Meeting Notes

Project 2010-13.2 Phase 2 of Relay Loadability: Generation Standard Drafting Team

March 25-28, 2013

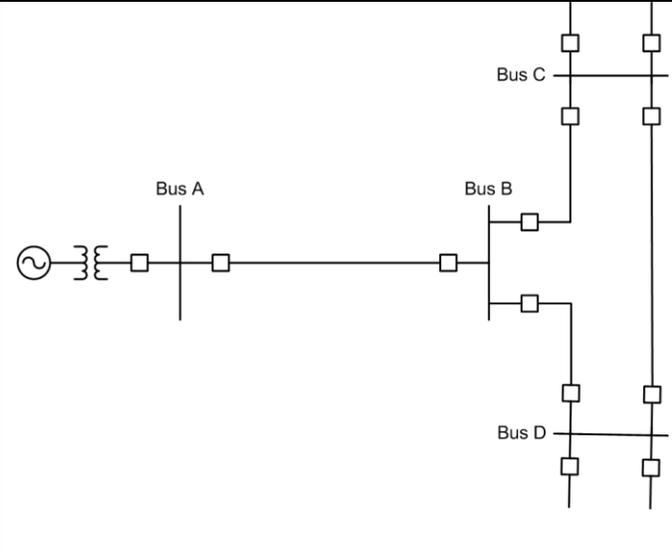
The team agreed that Figure 1 would illustrate discussions regarding the “generator interconnection Facilities”, and serve to illustrate that the “line” connecting generation to the network, regardless of ownership, would be properly captured with the changes to PRC-023-3.

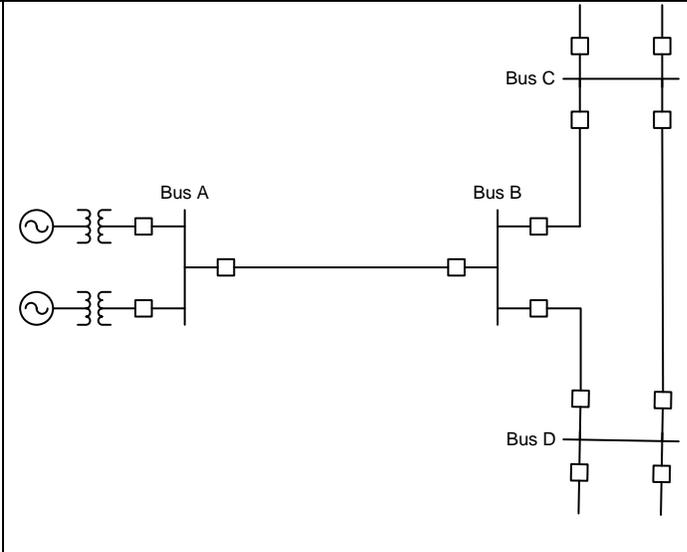
The team agreed that Figure 2 would not be necessary. It was noted that two generators on a single transmission line provided no additional clarity relative to Figure 1.

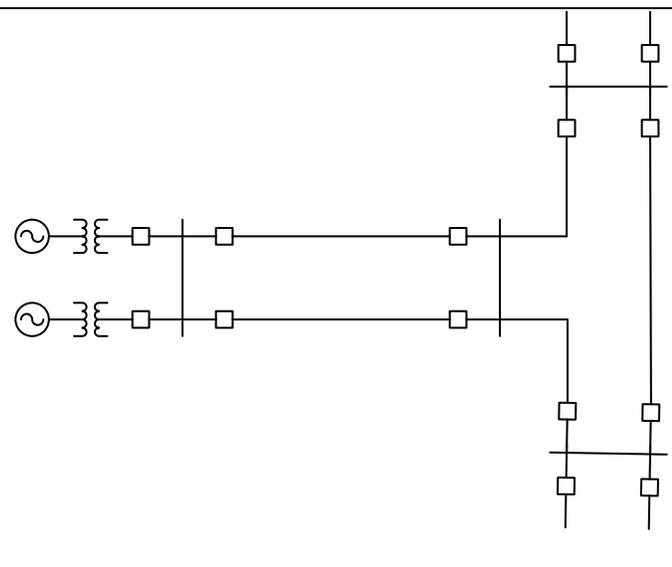
The team agreed that Figure 3 would result in the following condition. If a transmission line were tapped for load between the generation plant bus (like Bus A in Figure 4) on the right and the remote buses on the left (like Bus D in Figure 4) of the diagram, the breakers on the right (like Bus A in Figure 4) of the generation plant bus are subject to PRC-023; if no tap is present, the breakers on the right (like Bus A in Figure 4) of the generation plant bus are subject to PRC-025.

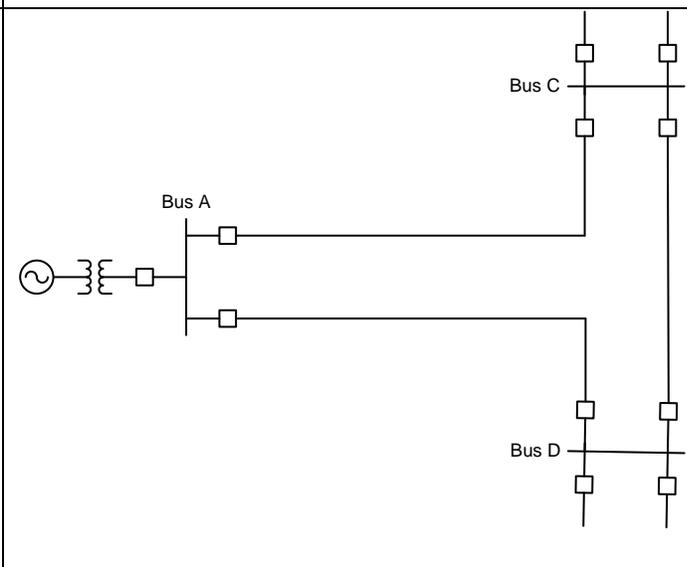
The team agreed that Figure 4 provides a reasonable representation of what breakers fall into what standard. Bus A (left side) is PRC-025-1 and Bus A (right side) is PRC-023-3. Buses C and D are PRC-023-3.
